**NSLPP MEETING HELD ON 03/02/21**

**ADDRESS/WARD:** 58 Cowdroy Avenue, Cammeray

**APPLICATION No:** Section 8.2 Review of Determination No. 3/20 (DA56/20)

**PROPOSAL:** Demolition of existing dwelling and construction of a new dwelling with associated tree removal and earthworks.

Figure 1: Amended Site Plan

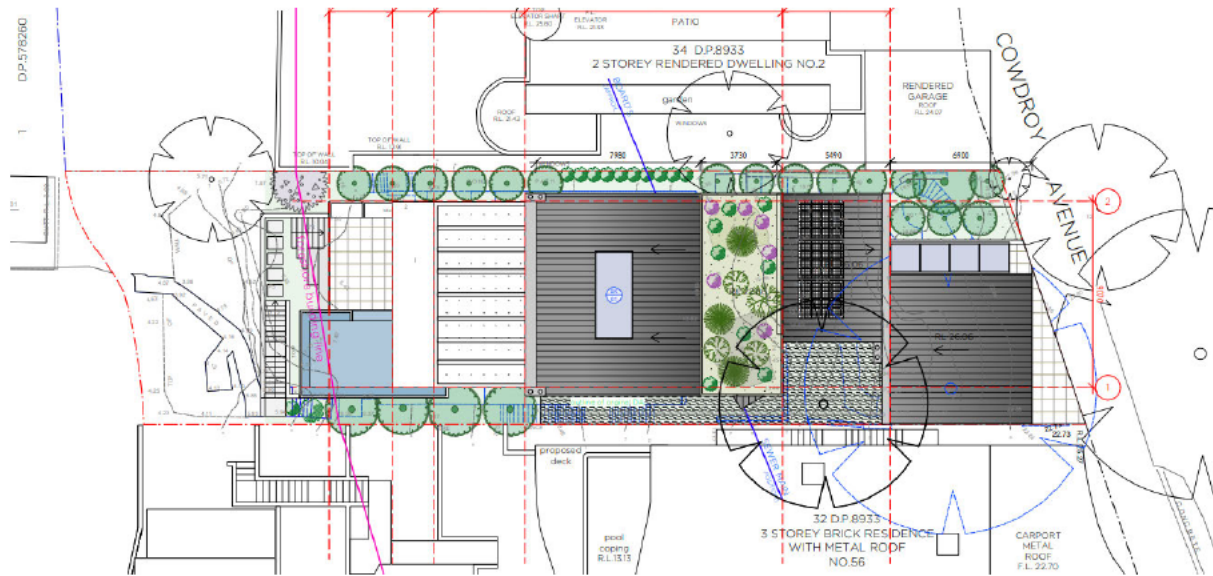
Significant excavation was proposed on the original proposal which is also a feature of the s.8.2 amended plans as is the removal of all trees across the site. The amended design has provided a small courtyard which may permit a replacement tree to be planted.

The foreshore building line is now marked on the submitted architectural plans and based on the FBL, it is clear that part of the proposed swimming pool associated with the new dwelling encroaches the foreshore in its northwest corner. There is also a minor encroachment of steps.

**Figure 10: ‘Building Height Blanket’ from applicant’s clause 4.6 submission showing original proposal and amended proposed height breach**

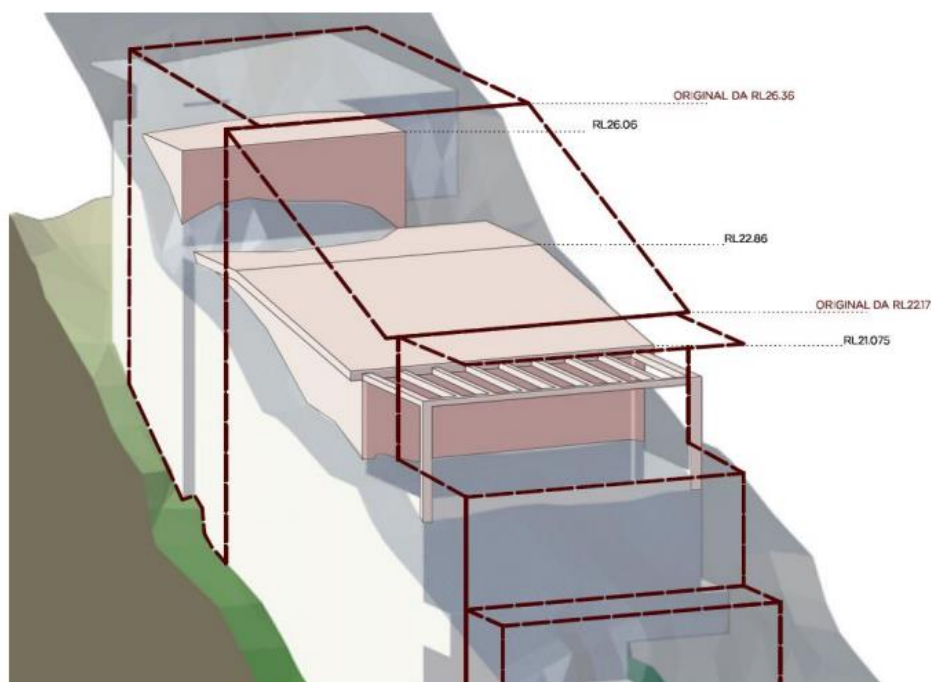
The submitted cl.4.6 submission and amended plans illustrate the proposed non-compliances as follows (refer to Figures 8, 9 & 10 below).

Further, the applicant's written request has not adequately addressed the matters referred to in subclause (3) of clause 4.6 as there are no unique circumstances of the case to justify the height variation as proposed, further, no convincing environmental planning grounds have been put forward to justify the variation.

The upper floor plan ceiling height as proposed, is considered excessive and could easily be reduced so that the height breach is substantially reduced, this would have the benefits of reducing overshadowing, view impacts and a lessening of the buildings bulk.

**Figure 11: Section from applicant’s covering letter showing topography and sewer mains constraints.**

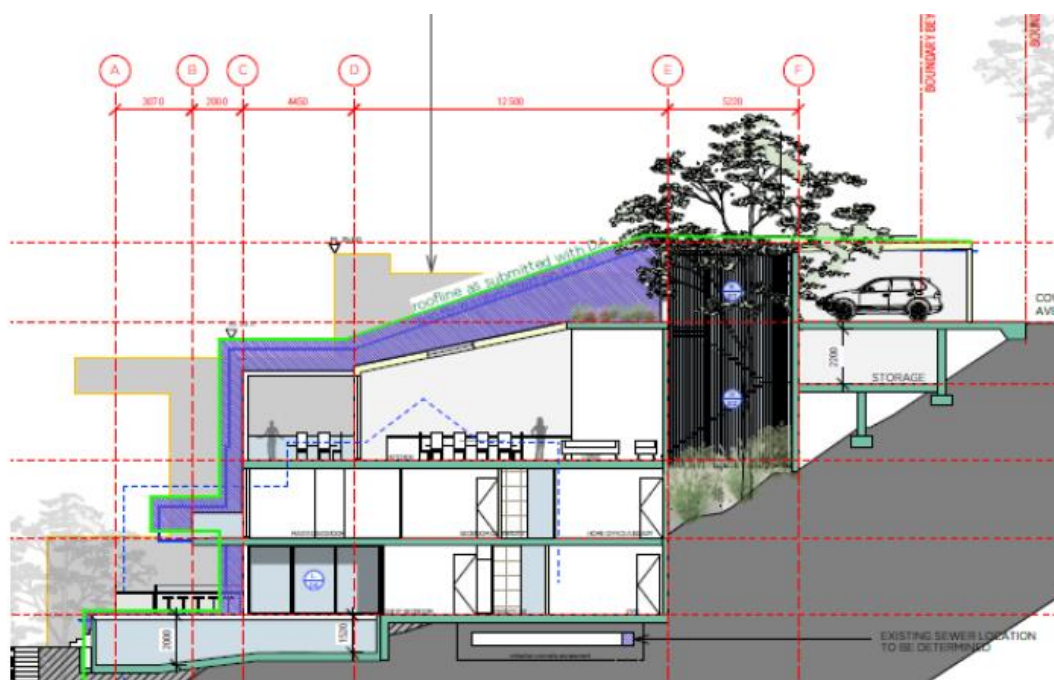
The steep topography is typical of most of the foreshore areas in the Sydney Harbour and affects many properties. Sydney Harbour is a ‘drowned river valley’ with relatively few level areas adjoining the foreshores. It is not considered that steep topography is unusual or a special circumstance of the case in this regard.

In relation to the location of the sewer, it is acknowledged that not all foreshore properties are affected by a sewer main. However, from viewing the section of the development the sewer does not appear to be a significant constraint as a two-storey development can easily be constructed over it, even a 3 storey with conservative ceiling heights and/or a minor variation to the height standard.

**Figure 13: Applicant’s ‘view loss montage’ of northeast view from 56 Cowdroy Ave, showing outline of original proposed building (rose shading), a minor modification lodged during assessment (blue shading), and, current amended proposal (light blue shading).**

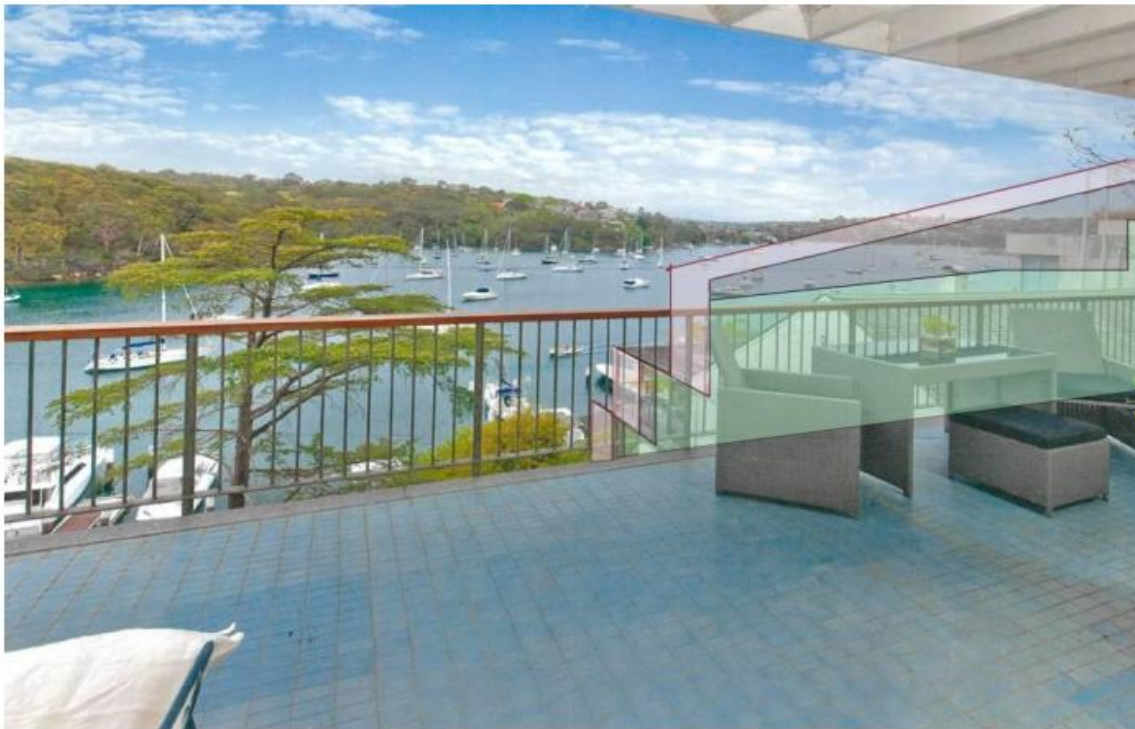
Whilst each of the 3 affected neighbouring properties will retain their northerly views to the rear, it is the side views that are to be impacted. As mentioned previously, the Tenacity principle does not dismiss side boundary views, merely notes that their retention is 'often' unrealistic.

The view assessment shown above (**Figure 13**) is the only photograph with superimposed building outlines that has been provided with the current review application and clause 4.6 submission, the view impact from the lower levels of No. 56, and, the two other properties has not been demonstrated.
